DART AEROSPACE LTD	Work Order: 73072
Description: Crosstube Assembly (412 High Aft)	Part Number: D412-664-243
Inspection Dwg: D412-664-243 Rev: E	Page 1 of 1

DRAWING NO. D412-664-243	TITLE CROSSTUBE ASSEMBLY (412 HI AFT)	REV. E	DART AEROSPACE LTD ENGINEERING ORDER		D.E.O. NO. D412-664-243-E-1	SHEET NO. SHEET 1 OF 2	SCALE NTS
DRAWN	CHECKED	MFG. APPR.	APPROVED	DE APPR.			
DATE 11.03.31	DATE 11/03.31	DATE 11.03.31	DATE 11/03.31	DATE 11.03.31

REMOVED ABRASION STRIP IN FAVOR OF A THIN LAYER OF PROSEAL 890.

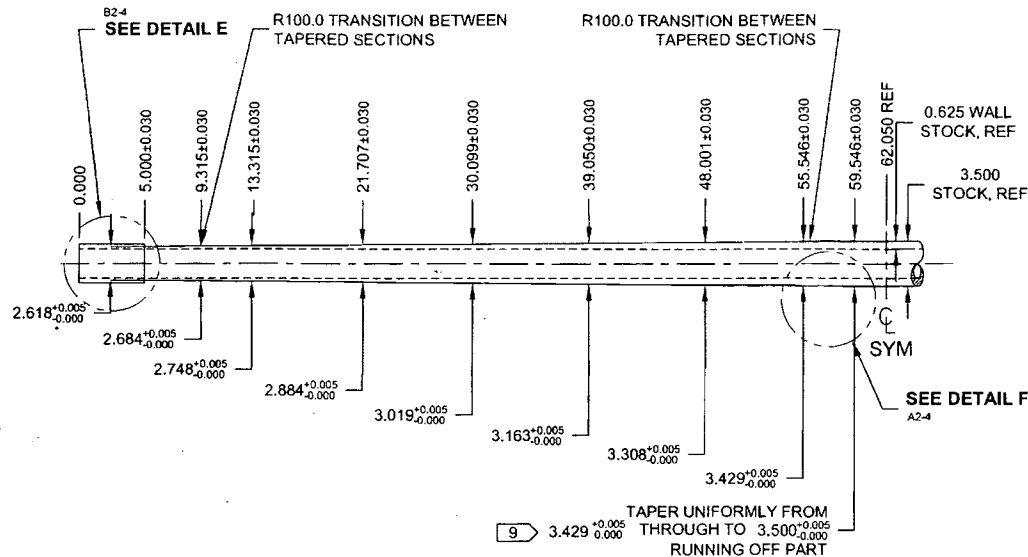
PARTS LIST IS AMENDED AS FOLLOWS:

Item	Qty -243	Part Number	Description
6	0	D2856-600-1009	ABRASION STRIP

6	2	D2856-600-1009	ABRASION STRIP
---	---	----------------	----------------

NOTES 2 AND 14, SHEET 1 ARE AMENDED AS FOLLOWS:

- 2) FINISH: CHEMICAL CONVERSION COAT PER DART QSI 005 4.1
PRIME INSIDE AND OUTSIDE PER DART QSI 005 4.2
PAINT OUTSIDE PER DART QSI 005 4.2
- 14) INSTALL D2856-600-1009 ABRASION STRIPS WITH A 0.13 REF GAP ON BOTTOM SIDE OF
CROSSTUBE PER QSI 035.

14 16
D2856-600-1009 ABRASION STRIP
D3189-1 CHAFING SHIELD (1, INSTALLED OVER ABRASION STRIP)
MS21920-28 CLAMP, 2X
2 PL

- 2) FINISH: CHEMICAL CONVERSION COAT PER DART QSI 005 4.1
PRIME INSIDE AND OUTSIDE PER DART QSI 005 4.2
MASK UNDERSIDE OF CROSSTUBE AS SHOWN (HATCHED AREA)
PAINT OUTSIDE PER DART QSI 005 4.2
AFTER PAINTING, APPLY CLEAR COAT ON HATCHED AREA
- 14) APPLY A THIN COAT OF PROSEAL 890 ON INSIDE CONCAVE SURFACE OF D3189-1
CHAFING SHIELD AND LET CURE PER MANUFACTURER'S INSTRUCTIONS. INSTALL
PROSEAL D3189-1 CHAFING SHIELD ONTO CROSSTUBE BY APPLYING A THIN COAT OF
PROSEAL 890 ONTO CROSSTUBE. BE SURE TO ELIMINATE ANY AIR GAPS.

16 14
D3189-1 CHAFING SHIELD (1, INSTALLED OVER PROSEAL 890).
MS21920-28 CLAMP, 2X
2 PL

2
MASK AREA PRIOR TO PAINTING AND
APPLY CLEAR COAT AFTER PAINTING
